**CERTIFICATE OF APPROPRIATENESS**

**Property:** 1213 Harvard Street, Lot 9, Block 187, Houston Heights Subdivision. The property includes an altered historic 3,180 square foot, two-story wood frame single-family residence with a new two-story addition and a new two-story garage under construction. The property is a 6,600 square foot (50' x 133') interior lot.

**Proposal:** Alteration – Addition/Garage *Revision*

**NORTH SIDE ELEVATION**  
**EXISTING PRIOR TO CONSTRUCTION**

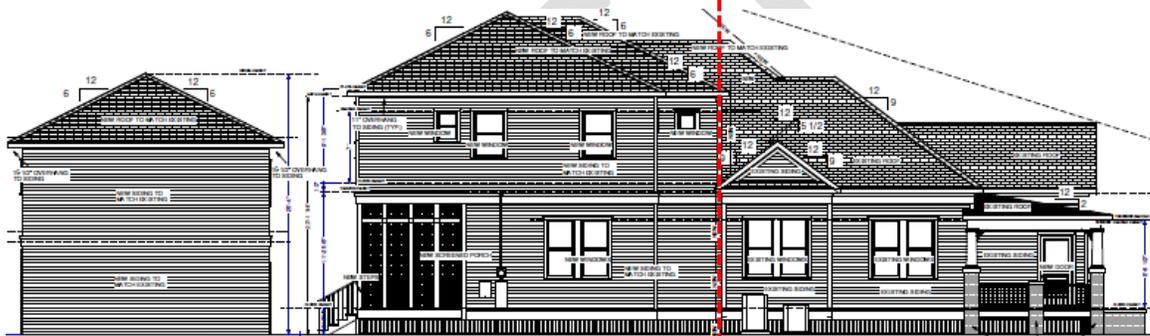
- Removed one original historic 1-over-1 wood window at the front of the north elevation of the original structure, enlarged the opening, and installed a pair of new 1-over-1 wood windows. According to the applicant, the historic window that was removed is in good condition and has since been installed on another house.
- Revised the fenestration pattern on the north and south side elevations of the addition.
- Connected the two-story detached garage to the rear of the house by a 9' 2" wide by 11' 1" deep breezeway.

- (1) The proposed activity must retain and preserve the historical character of the property;  
*Historic windows are a character defining feature of this residence. Replacing a historic window with two new windows, featuring new technology and materials, undermines the character of the property, as does altering the original opening and historic window pattern.*

- (4) The proposed activity must preserve the distinguishing qualities or character of the building, structure, object or site and its environment;  
*Historic wood windows are an irreplaceable distinguishing quality of this structure, and other Contributing structures found throughout Houston Heights Historic District East. Removing an undamaged historic window represents a failure to maintain the structure's distinguishing qualities.*

- (5) The proposed activity must maintain or replicate distinctive stylistic exterior features or examples of skilled craftsmanship that characterize the building, structure, object or site;  
*Historic wood windows feature characteristics of skilled craftsmanship no longer available, including old growth wood, interchangeable components, metal weights and pulleys. Replacing one of these windows with a pair of new windows represents a failure to maintain examples of skilled craftsmanship found on this structure.*

- (9) The proposed design for any exterior alterations or addition must not destroy significant historical, architectural or cultural material and must be compatible with the size, scale, material and character of the property and the area in which it is located;  
*Replacing an undamaged window with a pair of new windows represents a destruction of significant historical and architectural material. Portions of the original siding and wall material needed to be removed and discarded in order to incorporate the larger window opening.*

**Side Elevation:** Historic Structure: Replace the first window from the front wall with a pair of matching windows.

**(North)** Addition: Add a second 3' tall by 2' 8" wide 1-over-1 wood window next to an approved window of the same size and style. A 2' 8" wide by 11" tall transom windows will be added above each of these windows. Omitted an approved second floor window at the front of the approved addition. Omitted a single fixed window to the second story bathroom. Added a pair of 1' 9" tall by 1' 9" wide fixed window to the second story bathroom. Moved a pair of approved 5' tall by 3' wide windows at the north facing bedroom closer to the rear of the addition.

1213 Harvard – Question replacement of existing single window with new double window. Reduces historical material and context. Recommend a single historical period window be obtained and used to replace the double window installed and matching siding be installed to complete difference in opening area.

1. Approve the revisions to the fenestration on the north and south side of the addition.
2. Approve the breezeway connector between the garage and the rear of the house.
3. Deny the removal of one original historic window, enlargement of the original opening, and installation of a pair of new windows on the historic portion of the house.

**SOUTH SIDE ELEVATION**  
EXISTING PRIOR TO CONSTRUCTION

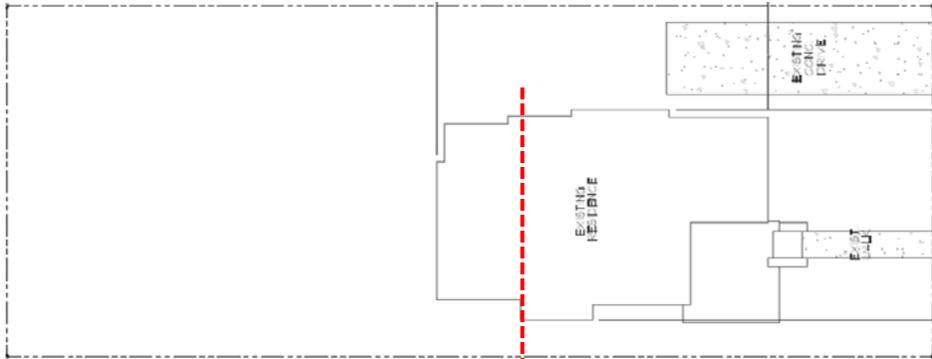
**(South)** Addition: Add a 2' 6" tall by 2' 6" wide fixed window to the first floor of the proposed stairwell. Omitted a pair of adjoining windows and replaced them with two 5' 9" tall by 2' 9" wide windows separated by approximately 8'. Add a 5' wide fireplace flue at the approved rear screened porch. The flue will be sided in wood cladding matching the addition. Add a 5' tall by 4' wide fixed window at the second story of the stairwell. Shifted a pair of approved windows at the second floor den closer to the front of the property. Added a pair of 1' 9" by 1' 9" fixed windows at the second floor bathroom.

SITE PLAN

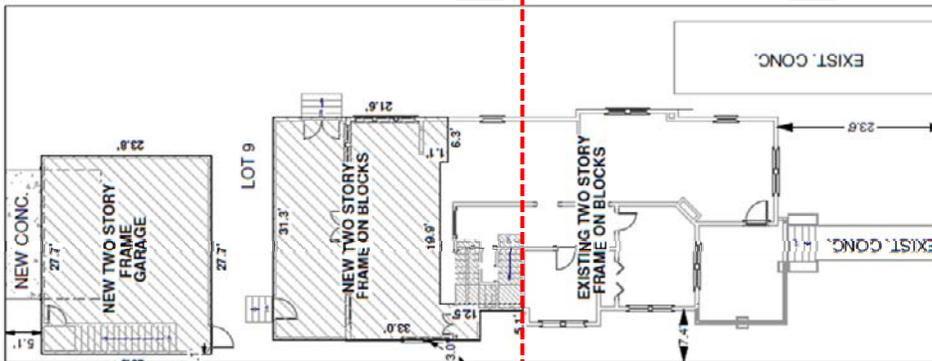
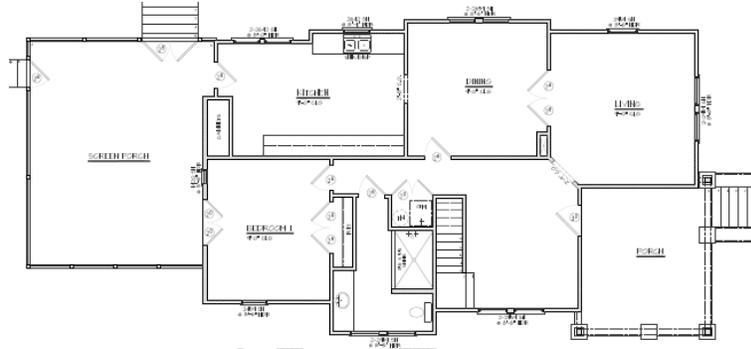
**Shape/Mass:** The applicant has been granted two COAs to construct a two story rear addition and one for a two story detached garage/apartment behind the addition. The applicant now requests approval to connect the addition to the garage apartment by a 9' 2" deep by 11' 1" wide wood breezeway.

Garage apartment: Garage will be attached to the main residence by a 9' 2" deep breezeway. A pair of 5' 9" tall by 3' wide windows will be added flanking a pair of single lite French doors on the first floor. The second floor will feature two 5' 9" tall by 3' wide windows.
